HORSHAM DISTRICT COUNCIL CONSULTATION

TO:	Horsham District Council – Planning Dept
LOCATION:	Land To The Rear of The Copse Worthing Road Horsham West Sussex
DESCRIPTION:	Construction of up to 23 residential dwellings, (including 9 affordable homes), including access, parking, landscaping and other associated infrastructure works.
REFERENCE:	DC/26/0355
RE-CONSULT:	1 st set of comments in black 2 nd set of comments in blue
RECOMMENDATION:	Holding Objection / More Information / Modification Advice / Modification

2nd set of comments

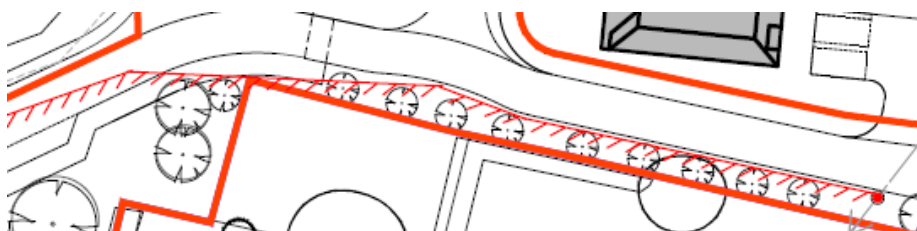
c. Proposed hedgerow differs between documents

Discrepancy remains within documents. See ILS [below, left] and Site Layout [below, right], the latter of which features only part of proposed hedgerow. Nonetheless, hedgerow as detailed within the ILS can be secured via condition. Closed.
